**COUNTY OF MIDDLESEX - INTERROGATORY #1**

Filed: May 23, 2013  
EB-2013-0040 and EB-2013-0041  
Exhibit B  
Tab 1  
Schedule 3  
Responses to County of  
Middlesex Interrogatories  
Appendix A

AREA	SUBJECT
1001 115kV TRANSMISSION LINE	STEEL POLE DESIGN PLAN & PROFILE DRAWINGS SHEET 1 OF 12
CLIENT DWG. NO.	REV.
DRAWING NO. 1235-2-P012-S1	G

PLS-CADD Drawing

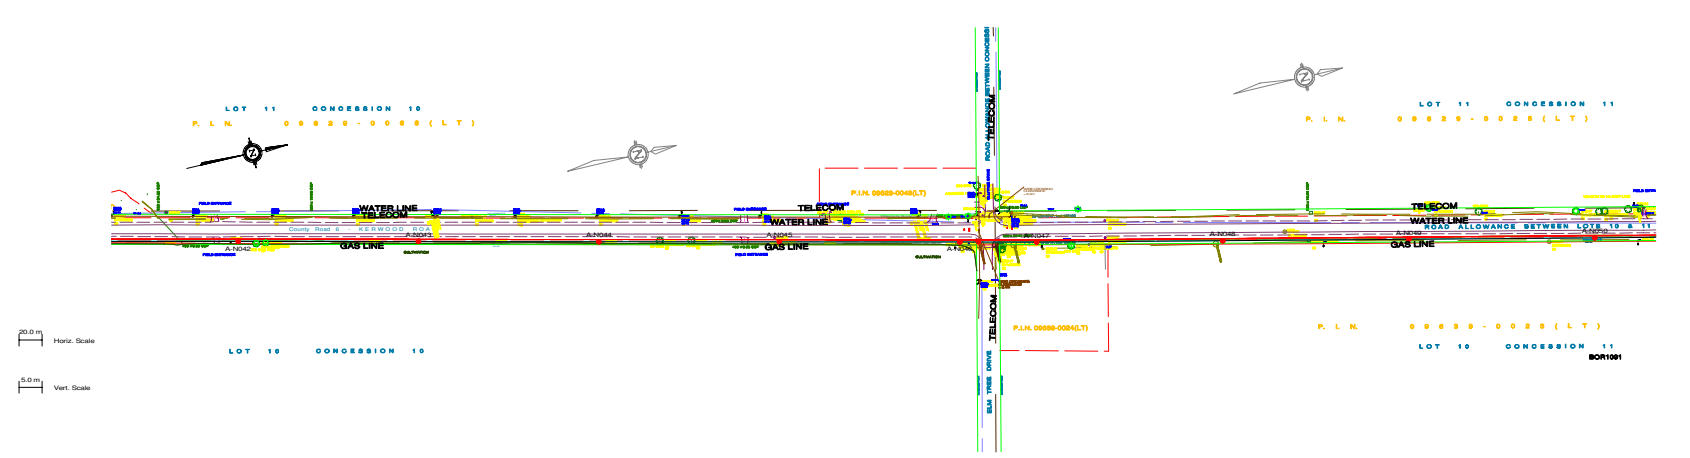
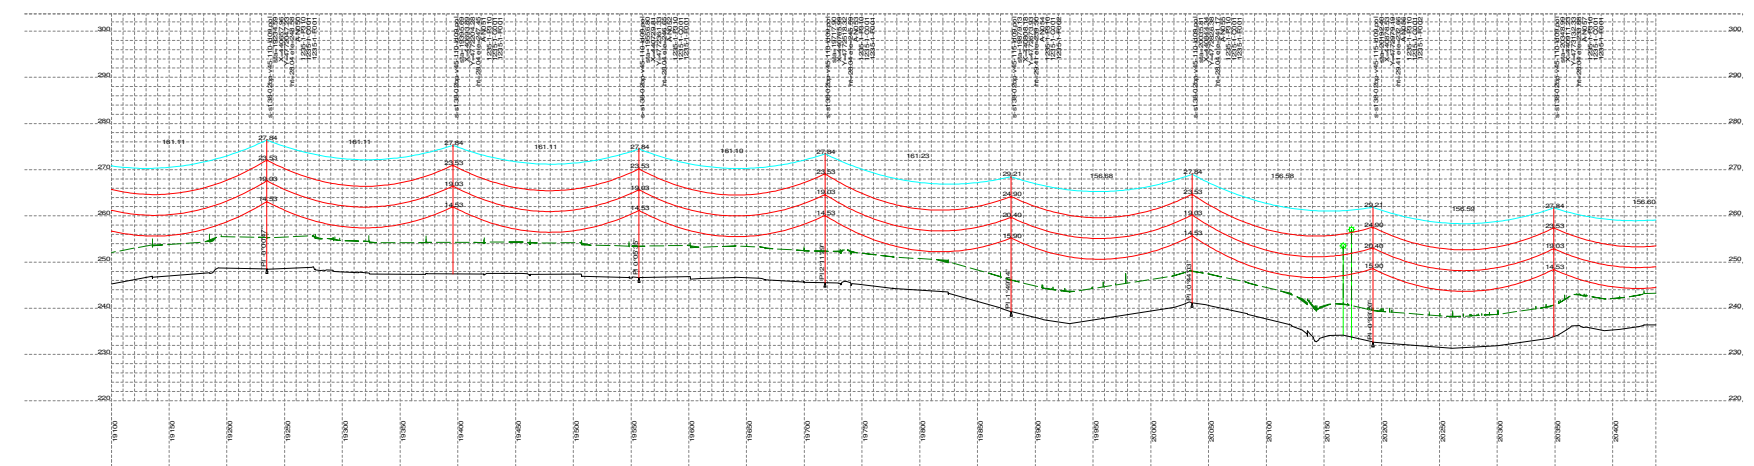
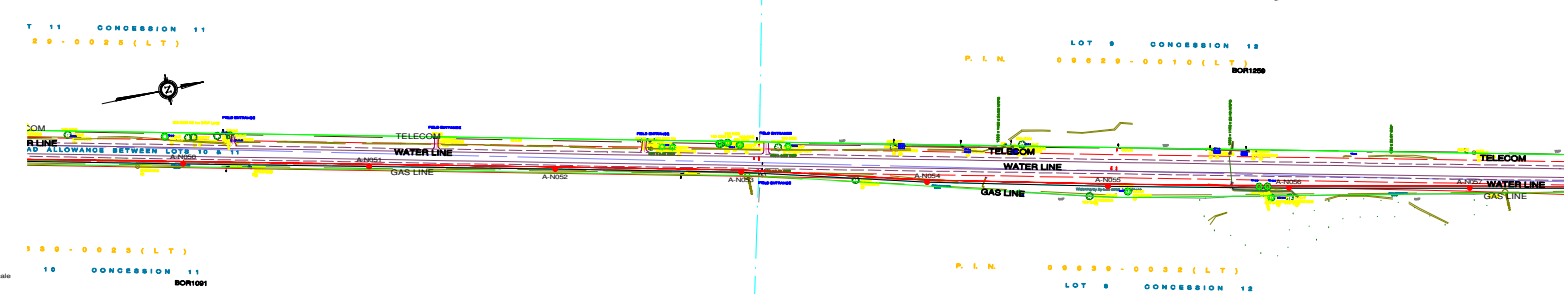
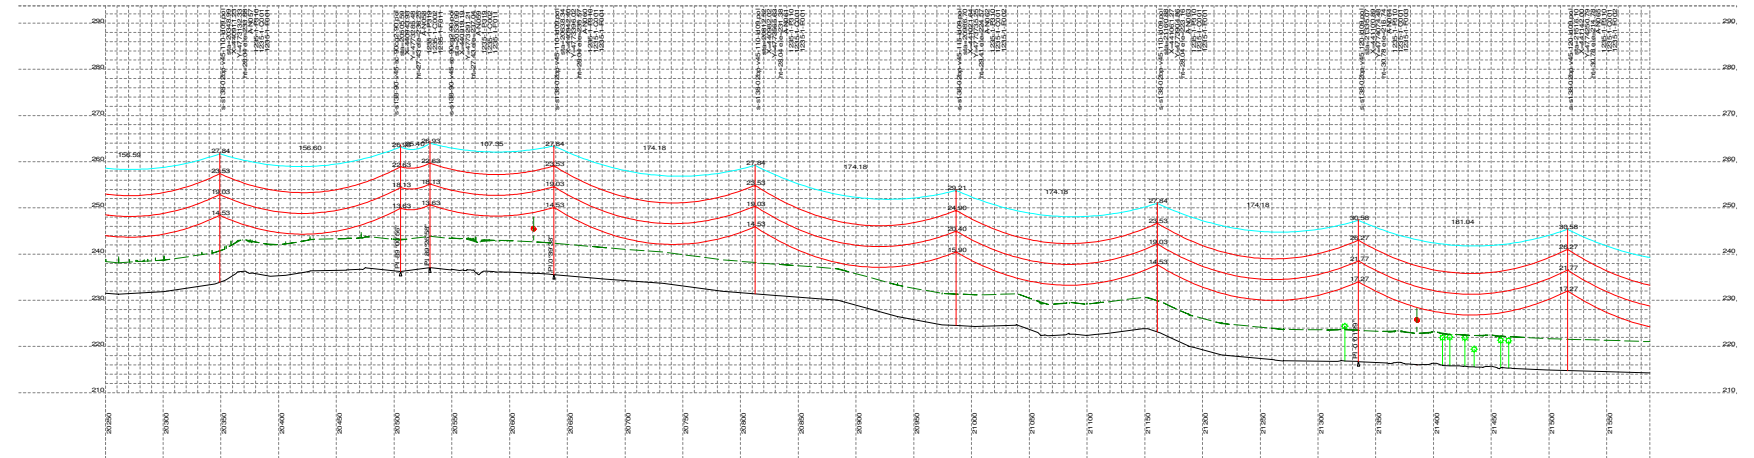
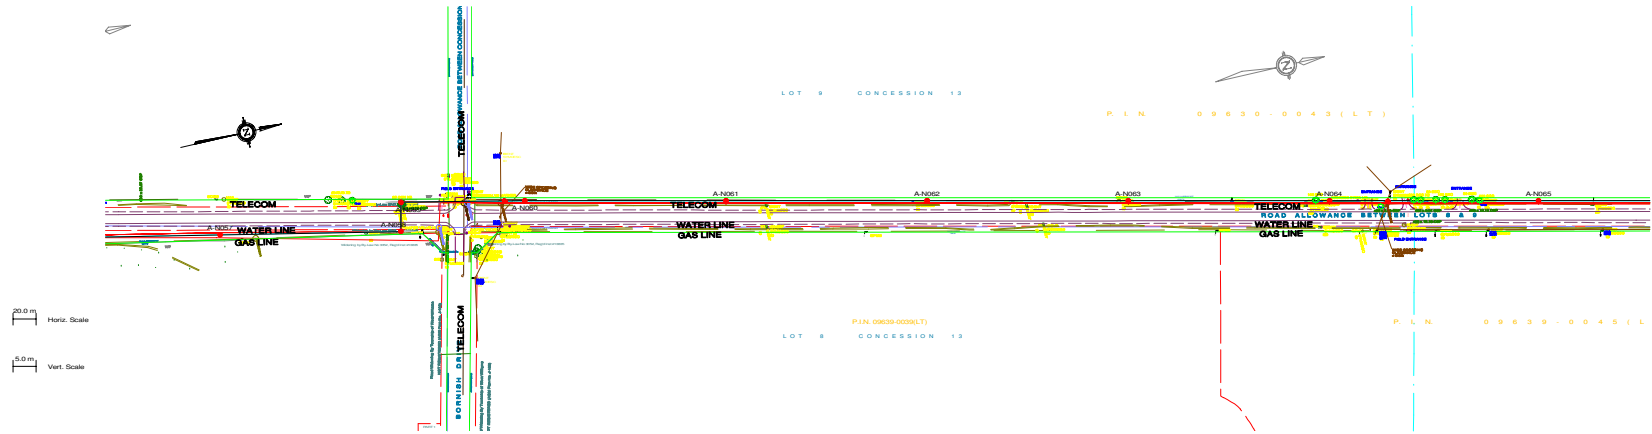
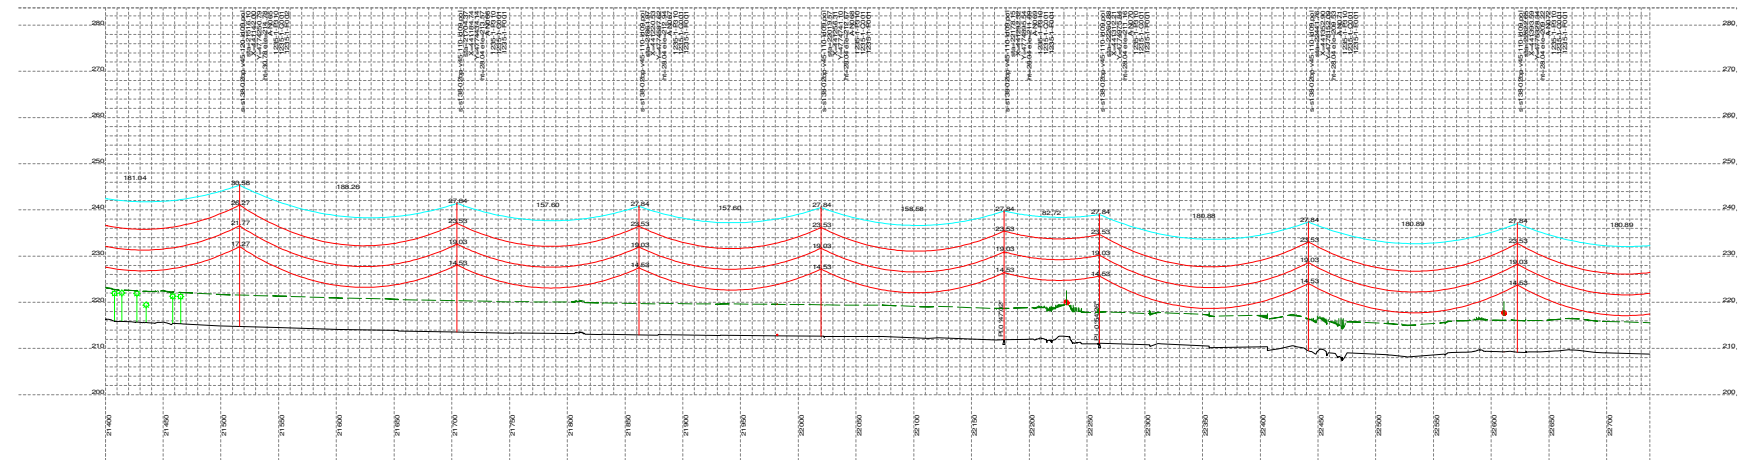
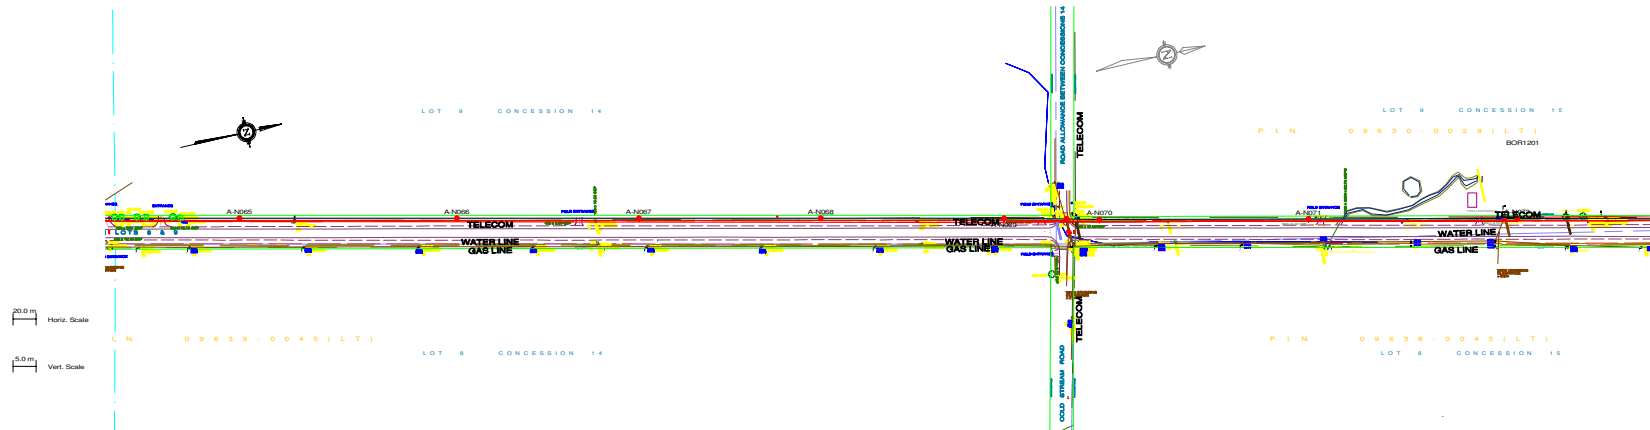
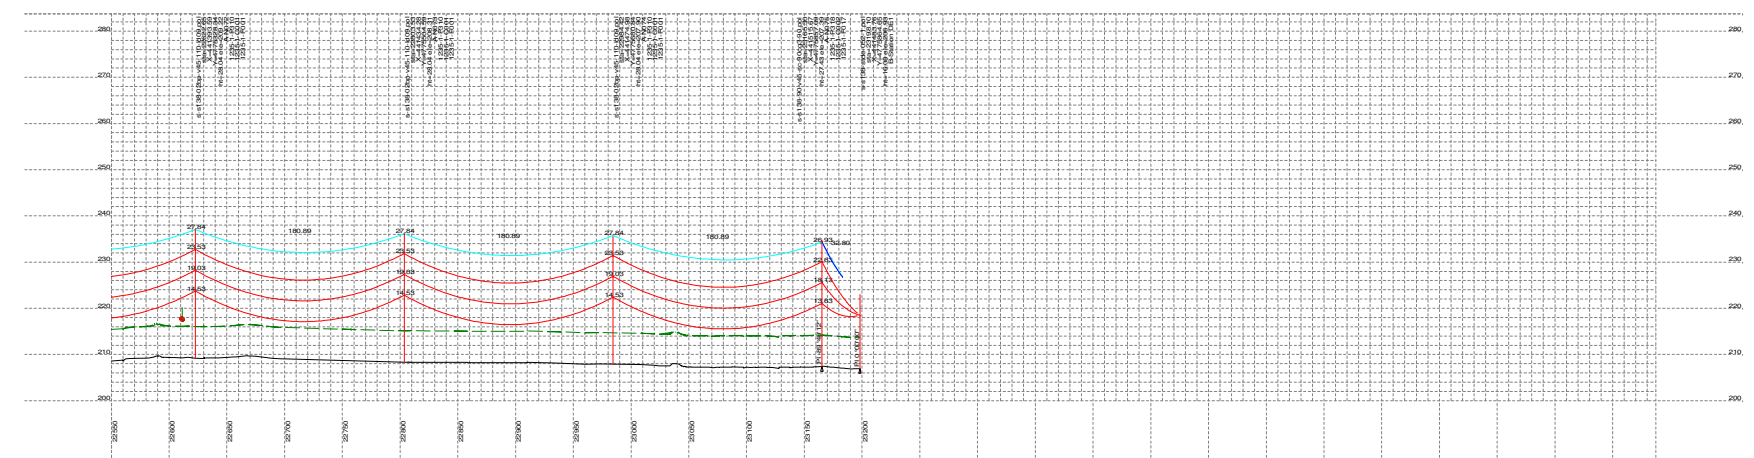
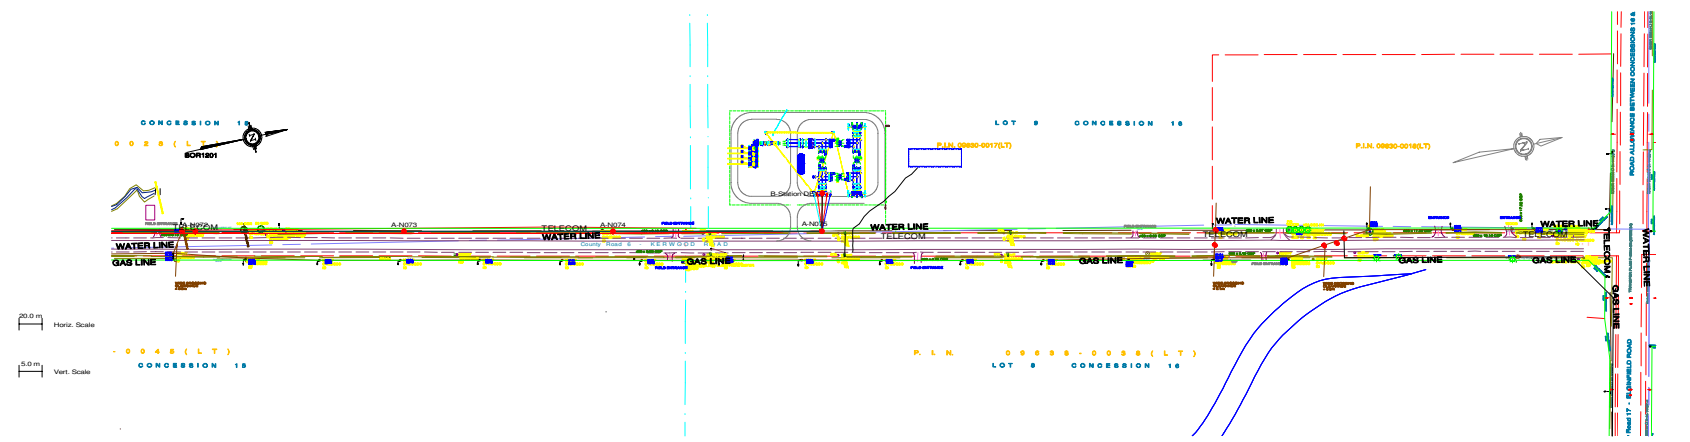
Please provide detailed engineering drawings showing the exact location of all poles and other appurtenances proposed to be located within County road allowances for transmission lines, including all material and construction specifications of poles, wires, guying, foundations, trenching, temporary conditions, and any other items related to this infrastructure.

Please see profile drawings in **Appendix 'A'** in respect of EB-2013-0040 and **Appendix 'B'** in respect of EB-2013-0041 depicting the current design, which is subject to final engineering. Earlier versions of these sets of drawings were provided to the County's Engineer on November 12, 2012. These drawings show the proposed pole, wire and anchor locations. Plans with respect to foundations, materials and construction specifications are not yet finalized. The physical design specifications for the proposed transmission line, including with respect to potential materials, are described in Exhibit D, Tab 1, Schedule 1. In addition, illustrations of potential pole structures and framing designs are provided in Figure 4 of Exhibit B, Tab 2, Schedule 5.
